HPSII Phosphate Mine

Alachua County Concerns

Springs

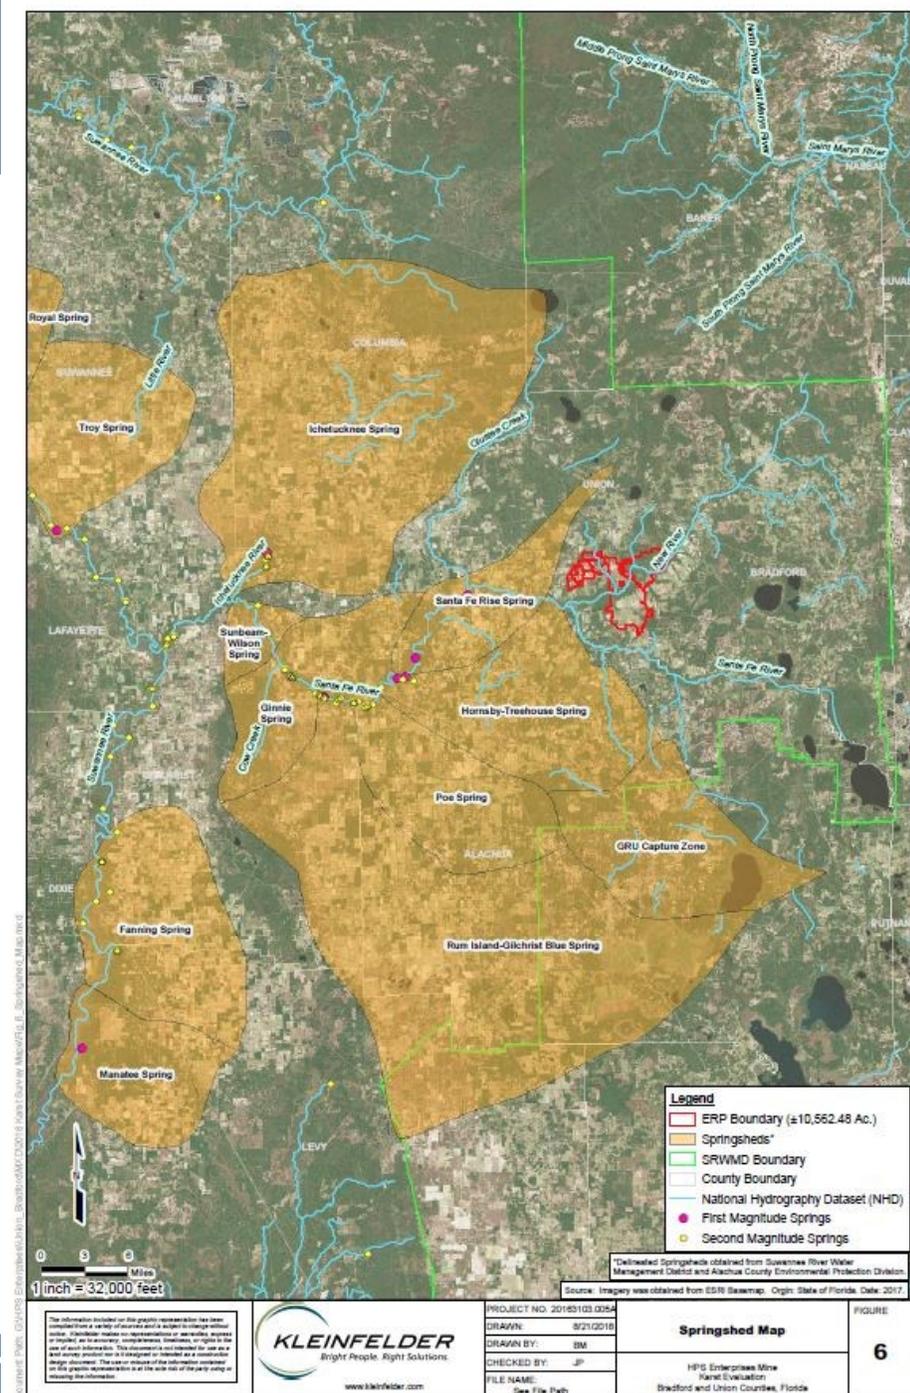
- Upchurch created most of the springshed delineations
- Floridan aquifer potentiometric data in Upper Santa Fe Basin was inadequate
- Unclear who drew springsheds near HPSII mine area

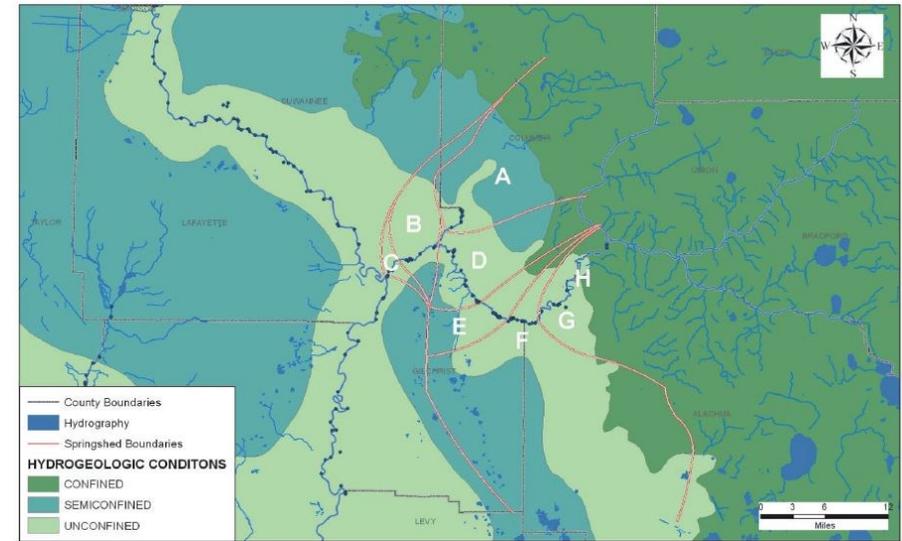
There isn't enough data to accurately delineate the springsheds of Worthington Spring, Treehouse/Hornsby springs, or the unnamed 2nd magnitude springs upstream from the River Sink

Karst

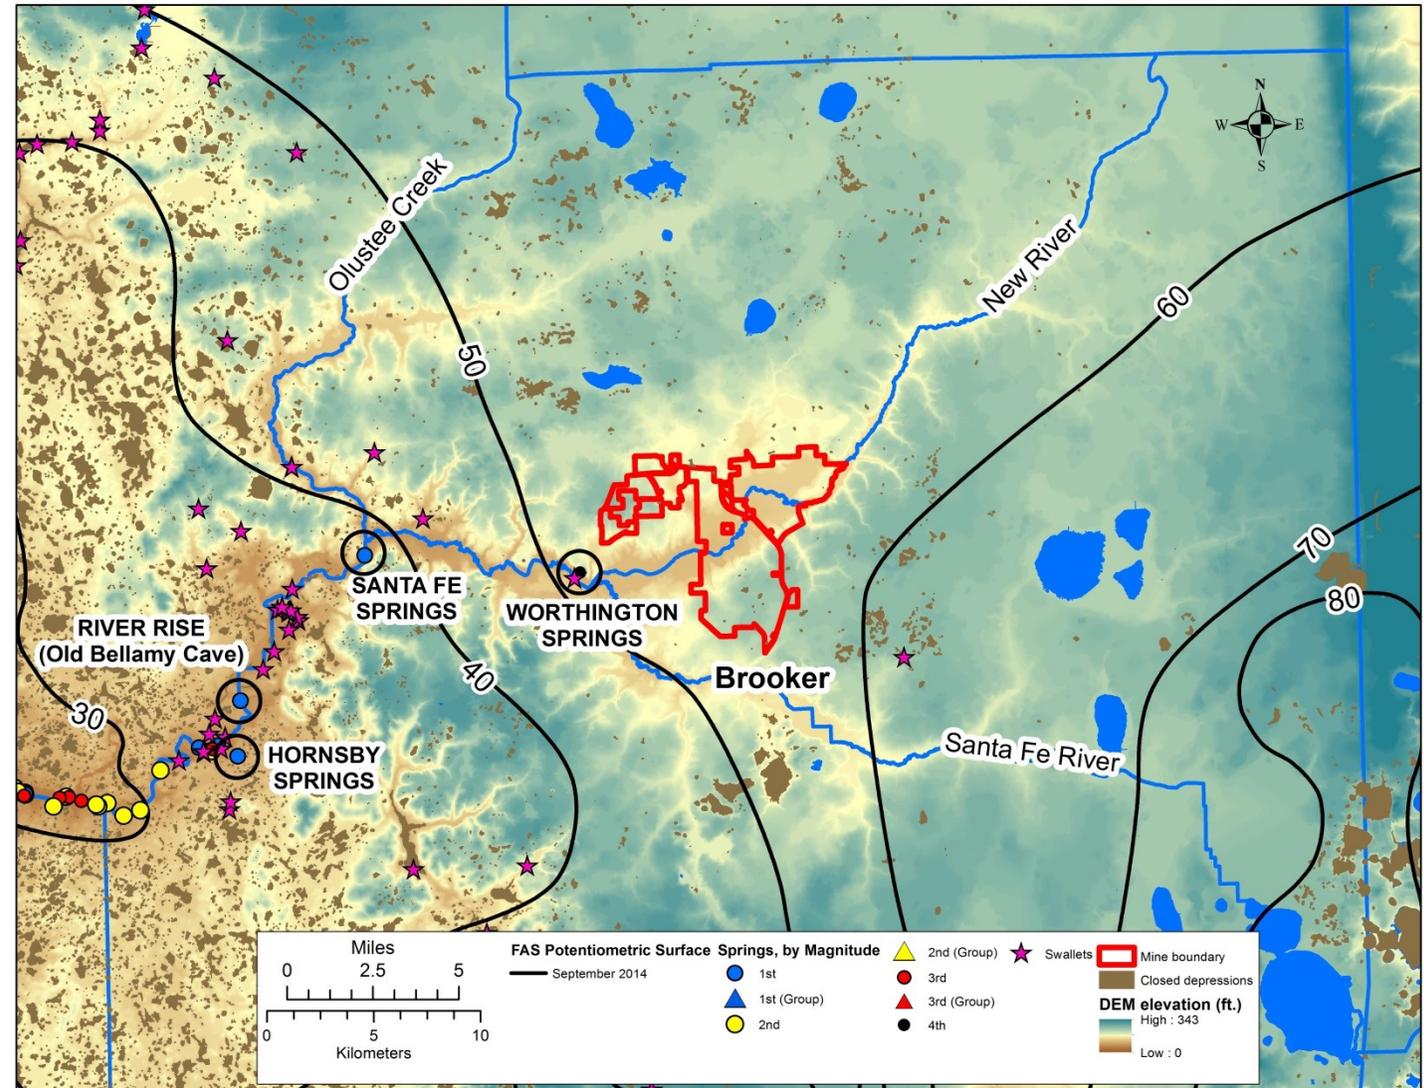
- Closed depressions are common at the upper (inner) margin of the Cody Scarp
- They have been noted on the HPSII mine site and nearby
- One monitoring well log in Karst Report (MW-18) reports “cavern” at 43 to 48 feet below land surface. Is this in the Charlton?

Karst

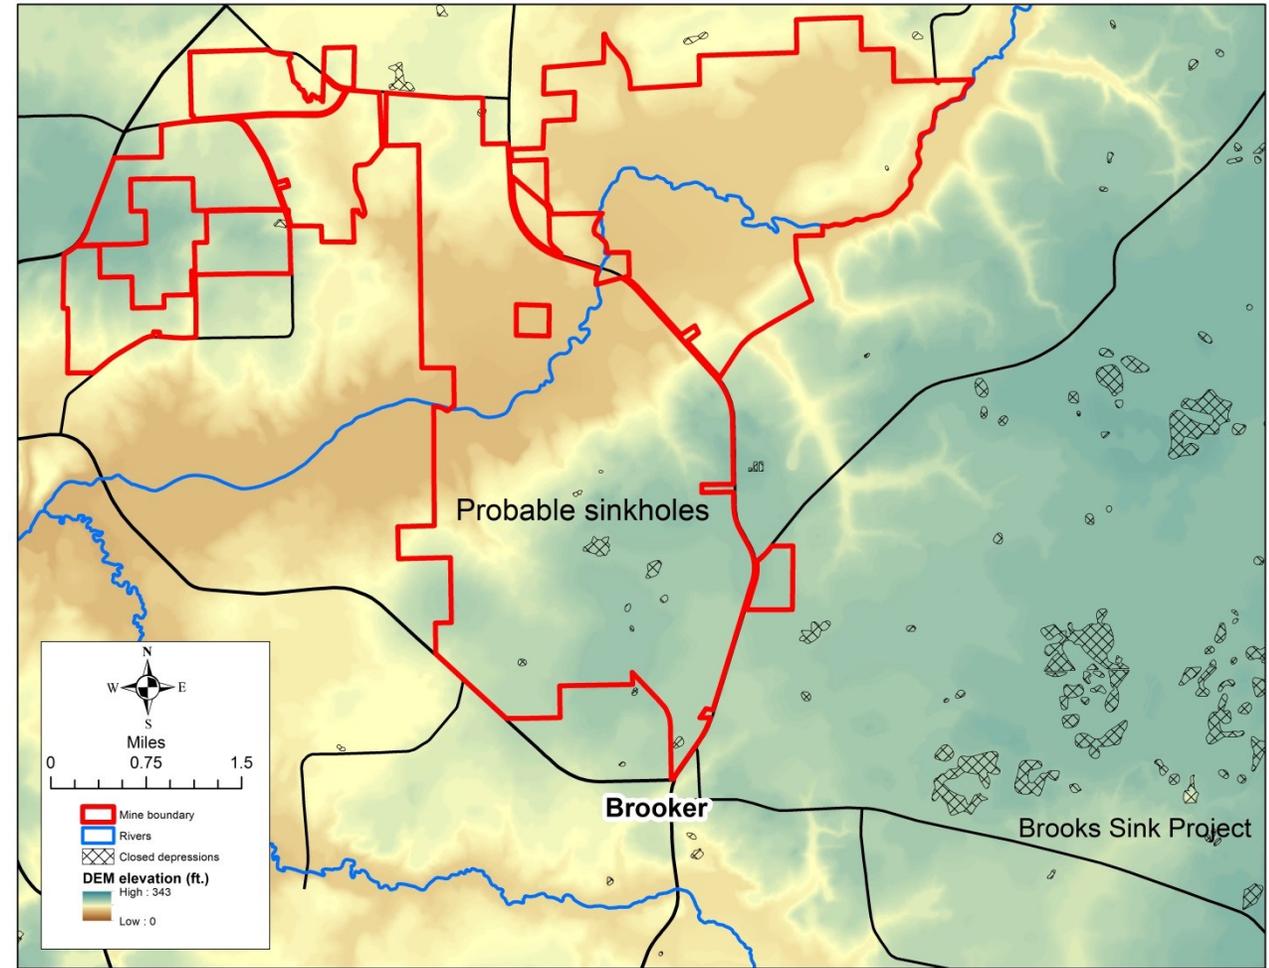
- There appear to be sinkholes on the mine property
- Known cover-collapse sinkholes exist several miles east of Brooker (i.e., Brooks Sink)
- Mining can cause sinkholes and alter water movement through existing sinks
- Need inventory of karst features
- Identify the impacts of mining on karst and recharge

Karst

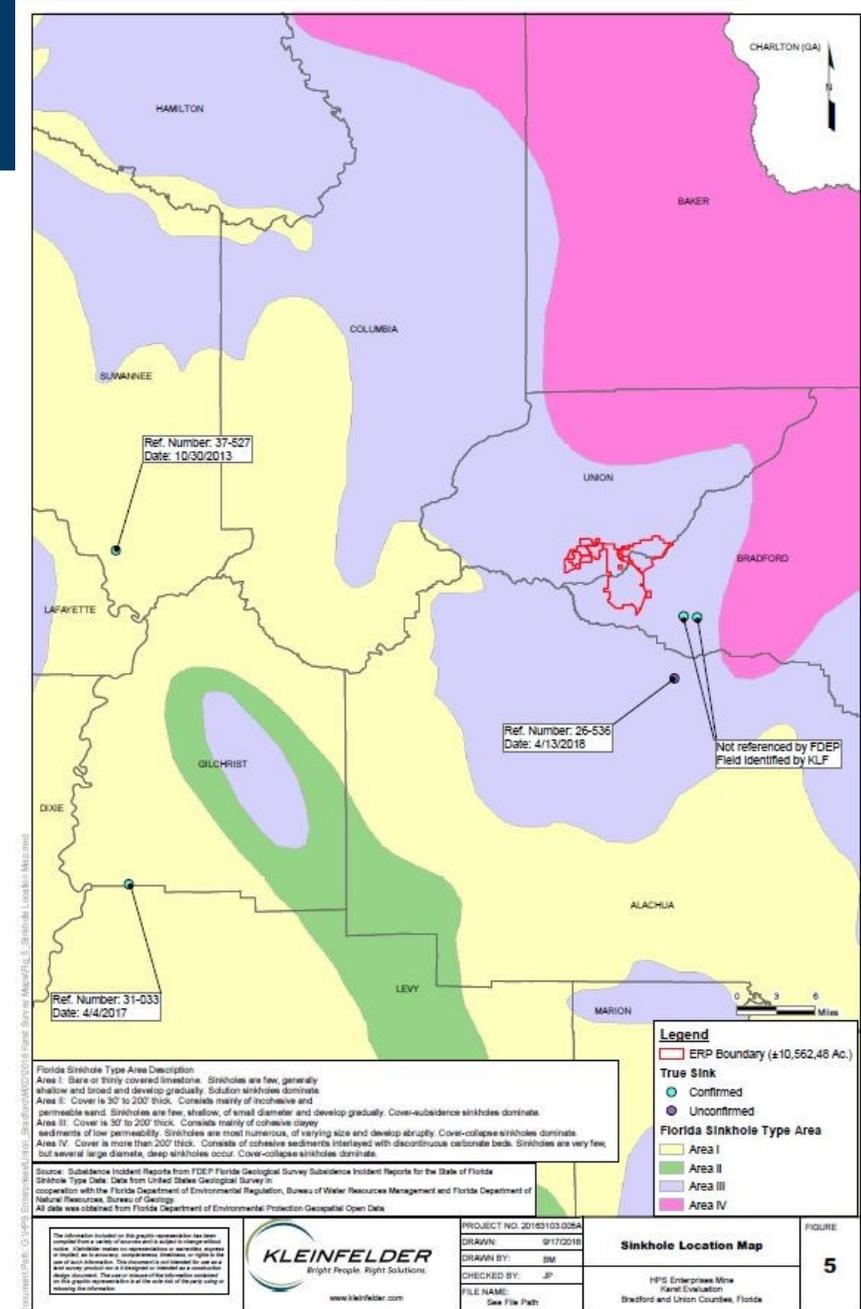
- HPSII Karst Report discusses karst and another report points out a “closed depression” in Union County.
- Closed depressions are ignored in Bradford County
- Circular wetlands and shallow closed depressions may well be relict sinkholes
- HPSII map assumes that Florida Geological Survey’s “Subsidence Incidence Database” is
 - Valid and comprehensive sinkhole database (it is not, as acknowledged by FGS)
 - Only modern “sinkholes” reported on the database are actual sinkholes

Mining Plan Floodplain Connection ERP 2/19

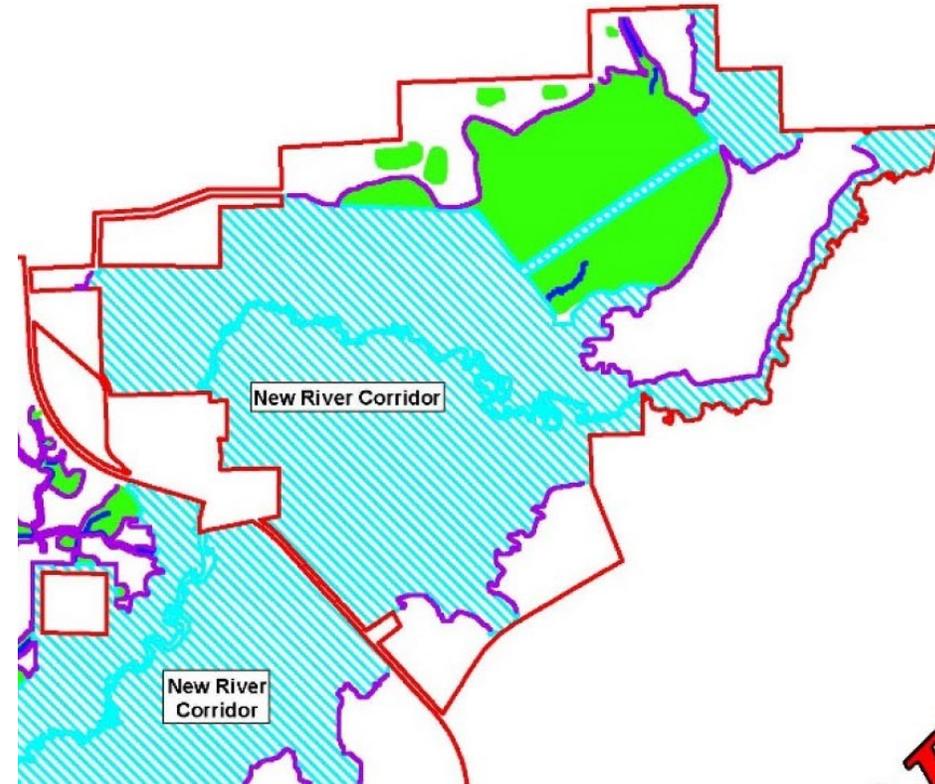
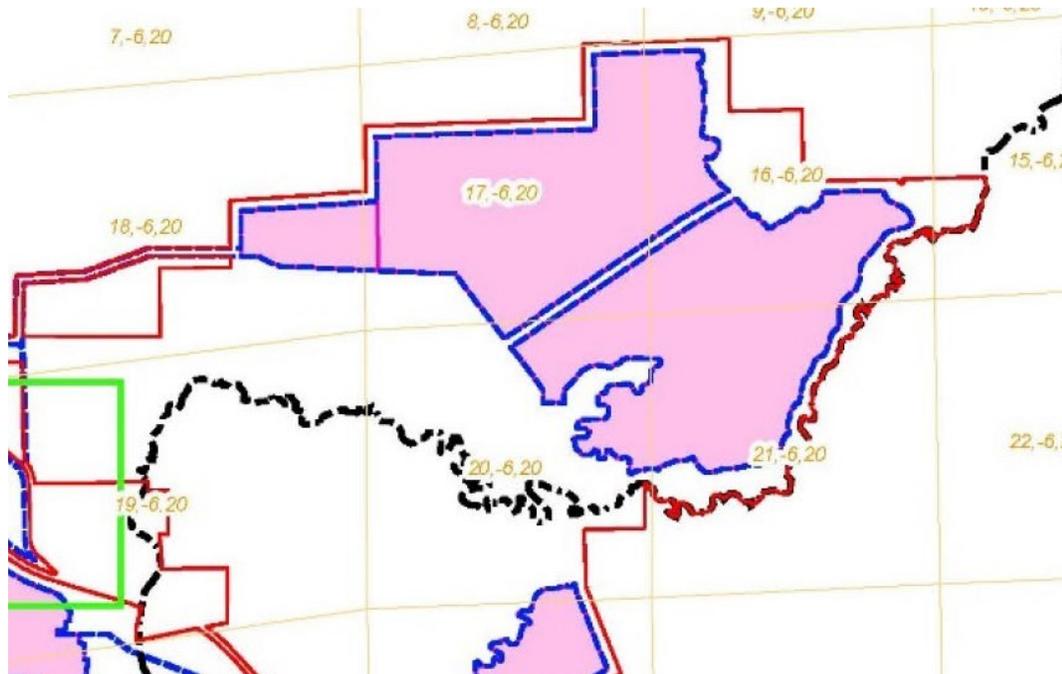
Note the diked channel to ensure stream connection

Upper Floodplain Connection ERP 3/19

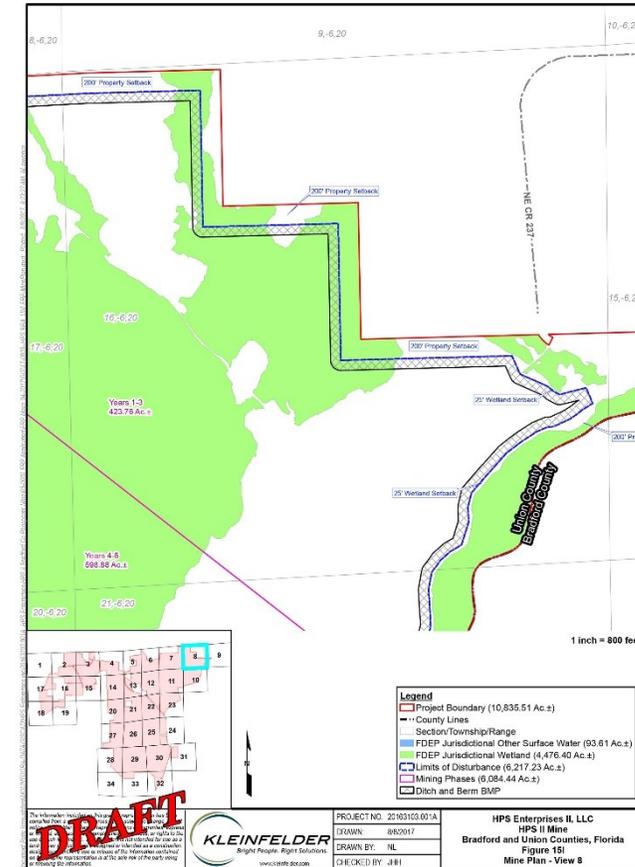
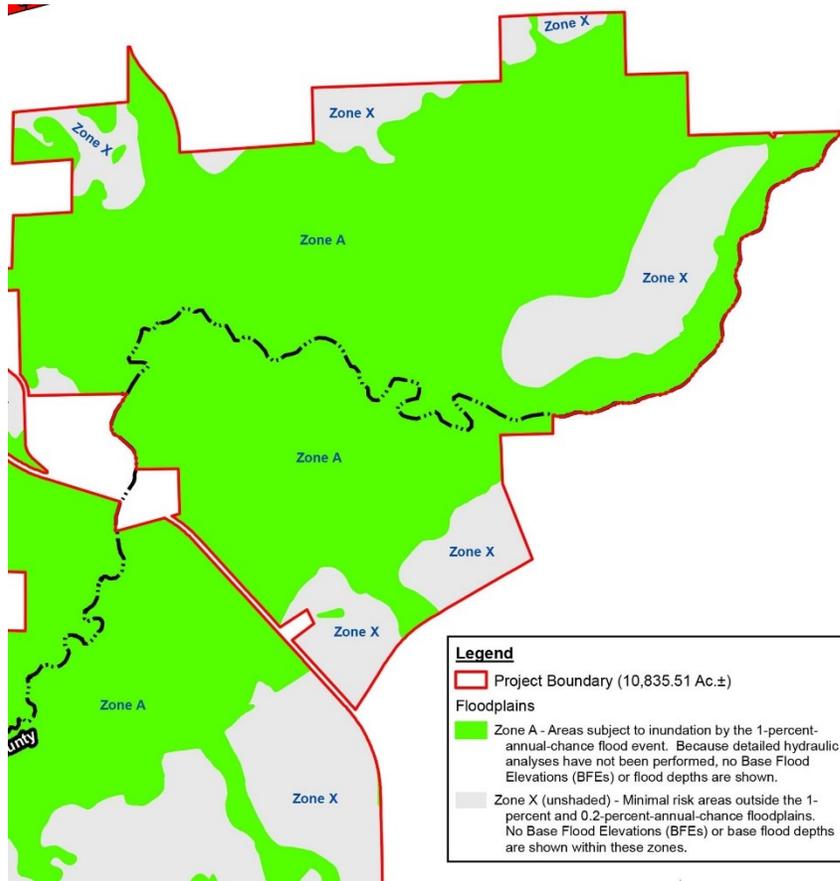
Note blockage of river entry and lack of connection to lower floodplain

Mined Area ERP 3/25

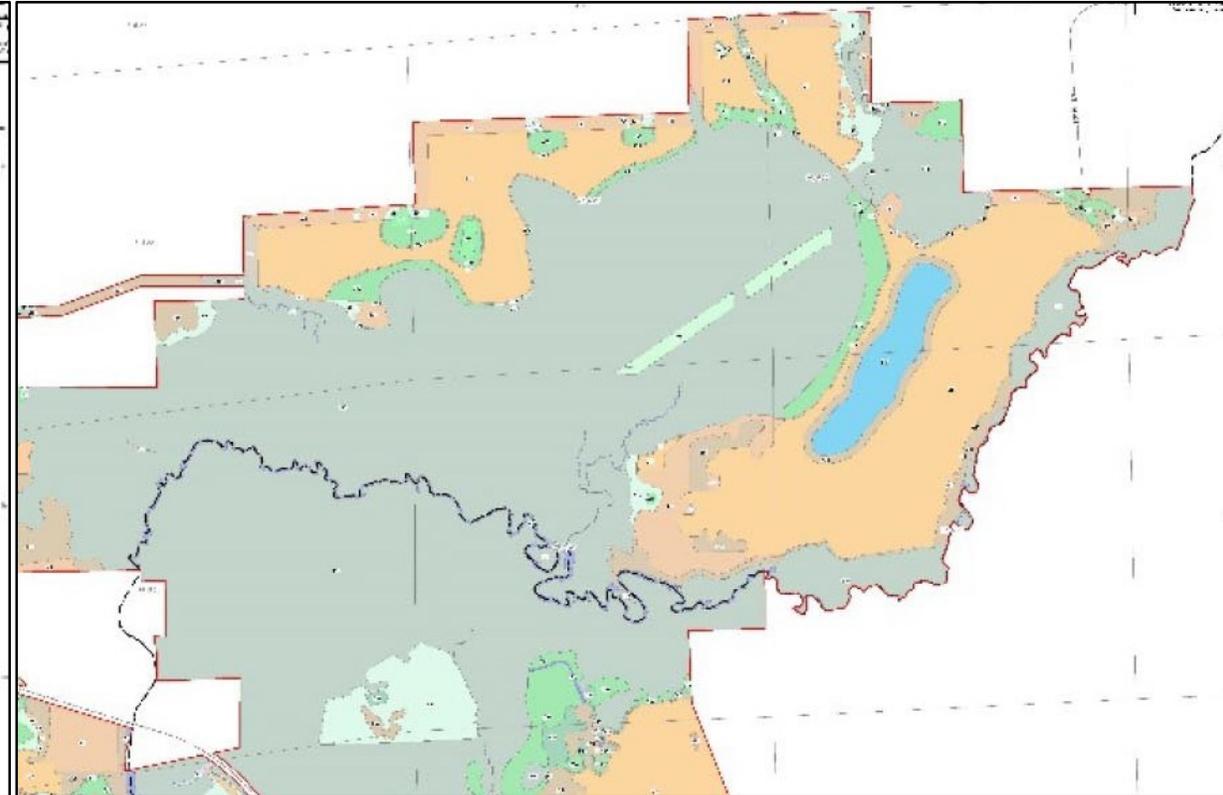
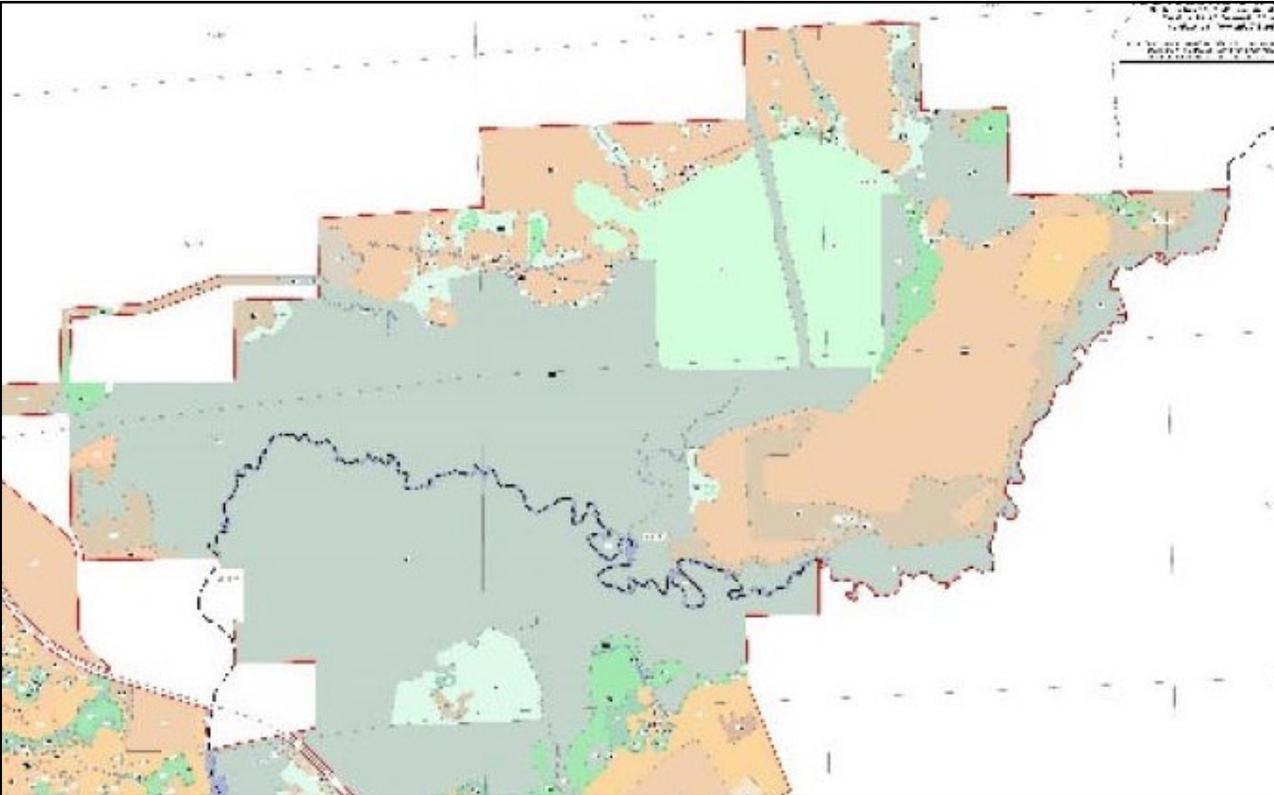
- Disconnect of river from floodplain
- No hydrologic connection through mined area
